These instructions will help you identify the differences between Yetter 2967-042 Row Cleaners acquired from John Deere and those acquired from Yetter. They detail the modifications necessary to adapt the 755160 CleanSweep kit to the John Deere-supplied version.

Identification

Figure A

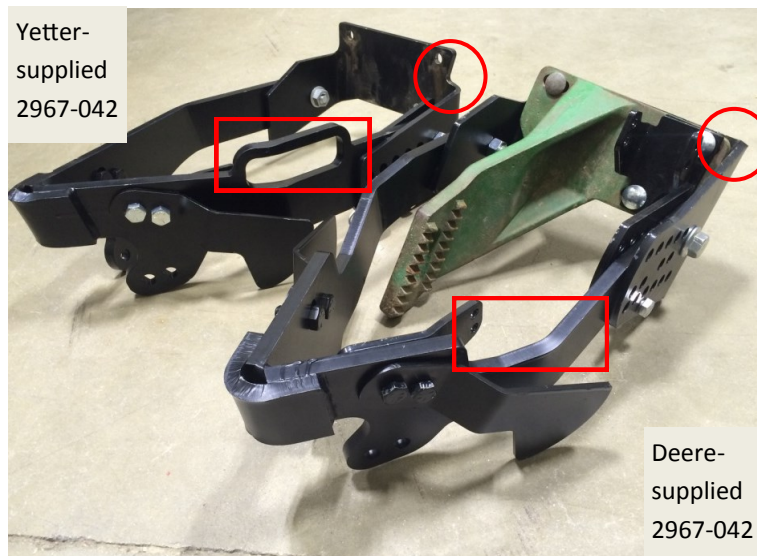
- The traditional aftermarket 2967-042 has a handle and a notch at the top of the mount bracket. No modification of kit 755160 is necessary.
- The new 2967-042 has no handle and no notch at the top of the mount bracket. This is being installed at the factory by John Deere and supplied to John Deere dealers as kit AA83727 ARM.

Figure 1

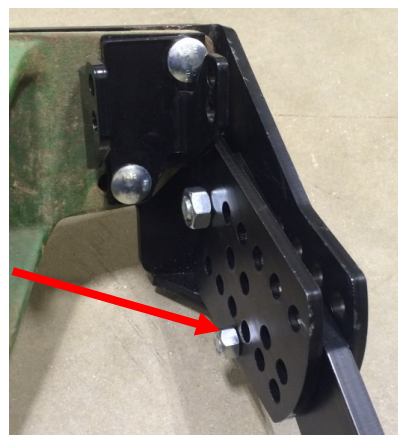
Remove the inside pin adjustment plate. This plate has interferes with the slightly narrower row cleaner frame.

Figure 2

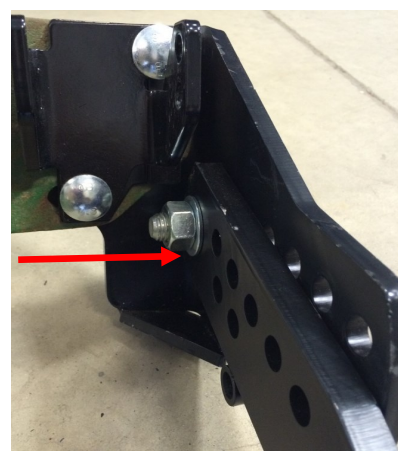
Add a 5/8" washer at the pivot. Ensure that the bushing remained in place inside of the row cleaner arm. Retighten this self locking nut.

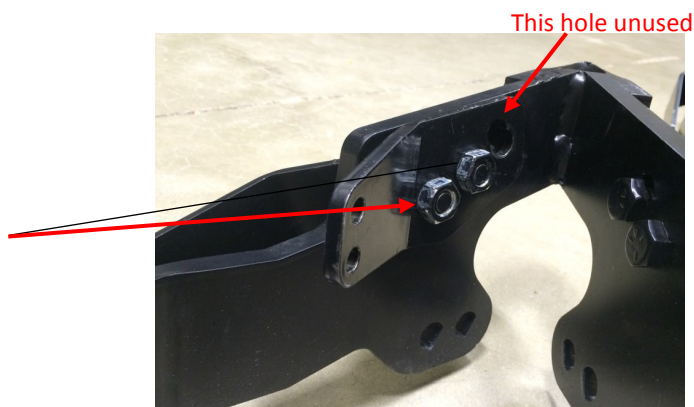
Install modified bracket on the row cleaner. Install the bracket on the left hand scraper bolts using the middle hole and the new hole created in Step 3.
